TRANS/WP.29/GRSP/2001/14  
4 September 2001

World Forum for Harmonization of Vehicle Regulations (WP.29)

PROPOSAL FOR DRAFT 06 SERIES OF AMENDMENTS TO REGULATION No. 14  
(Safety-belt anchorage)

Transmitted by the Expert from France

Figure 1: *Static force application device (S-FAD), isometric views*

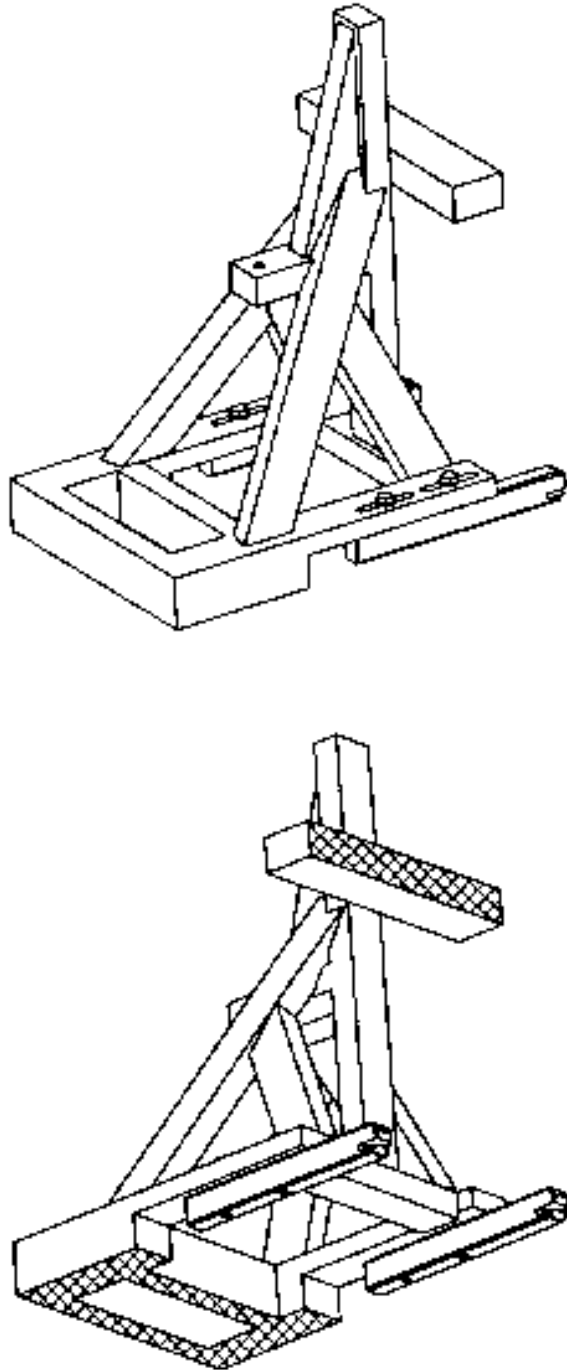
- 2.22. "Static force application device (S-FAD)" means a test fixture that engages the vehicle ISOFIX anchorages system and that is used to verify their strength and the ability of the vehicle or seat structure to limit the rotation in a static test. The test fixture is described in figures 1 and 2.

Insert figures 1 and 2, to read:  
"

Figure 2: Static force application device (S-FAD), dimensions

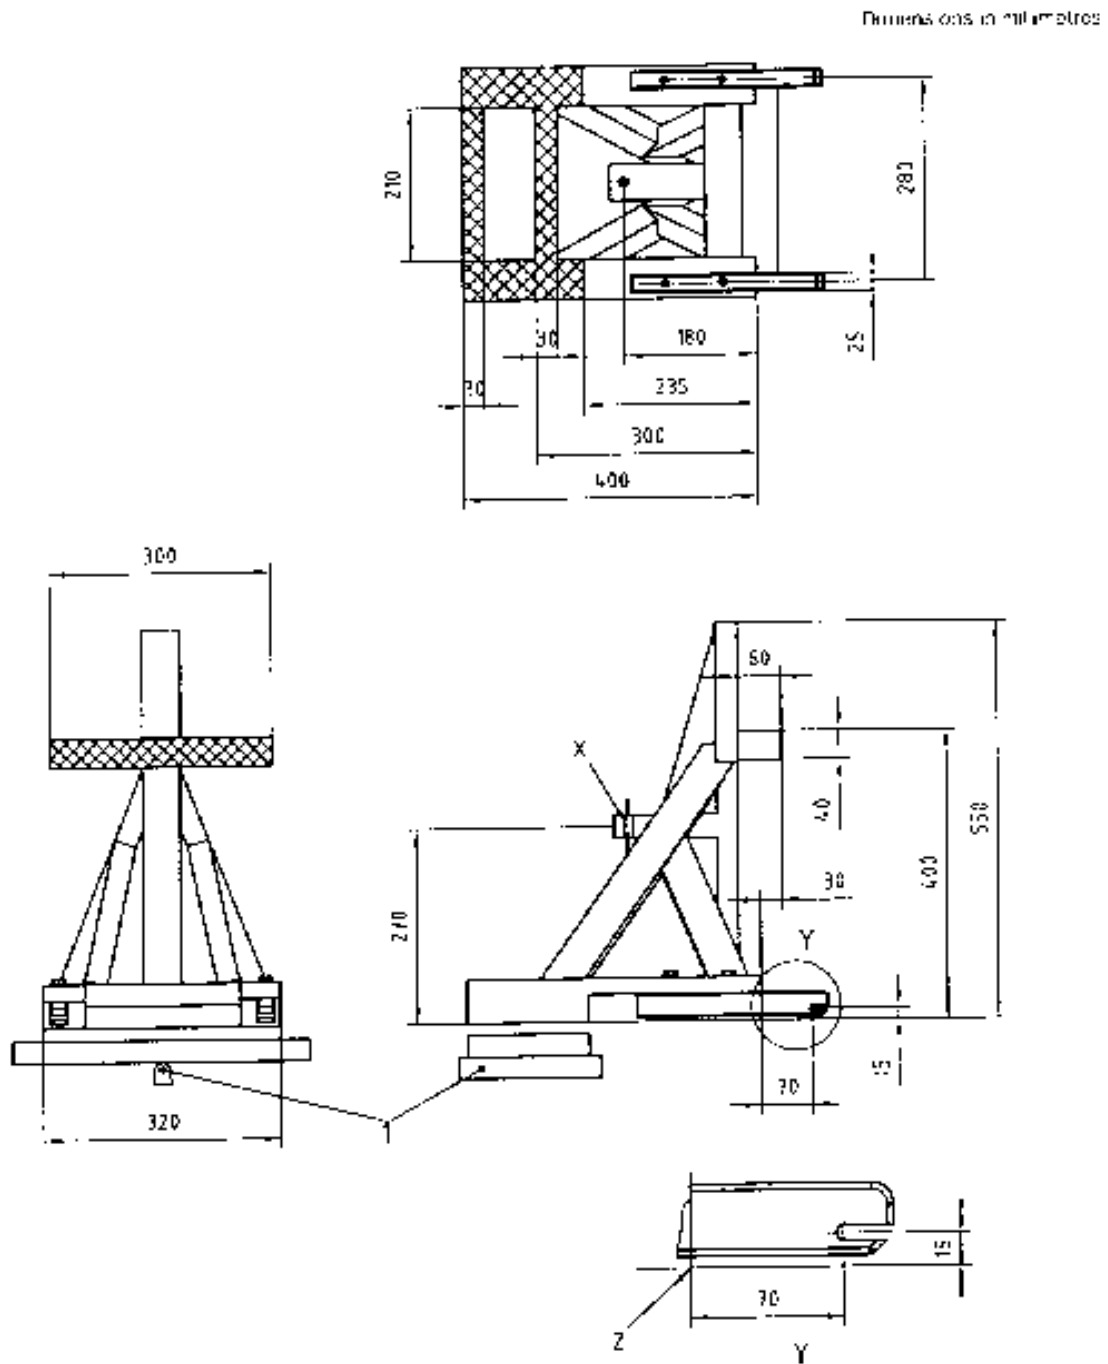
*Stiffness of S-FAD: When attached to rigid anchorage bar(s) with the front cross member of the S-FAD supported by a rigid bar that is held at the centre by a longitudinal pivot 25 mm below the S-FAD base (to allow bending and twisting of the S-FAD base) the movement of point X shall not be greater than 2 mm in any direction when forces are applied in accordance with table No. 1 of paragraph 6.6.4. of this regulation. Any deformation of the ISOFIX anchorages system shall be excluded from the measurements (e.g. the stiffness requirements will be fulfilled when using a securely welded construction consisting of rectangular 3 mm steel tubing, and 6 mm thick load application plate)."*

Forces in the forward direction shall be applied with an initial force application angle of 10  $\pm$  5° above the horizontal. Lateral forces shall be applied horizontally 0°  $\pm$  5°. A pre-load force of 500 N  $\pm$  25 N shall be applied at the prescribe loading point X indicated in figure 2. Full application of the force shall be achieved within a period of 2 s or less. The force shall be maintained for a minimum period of 0.2 s.
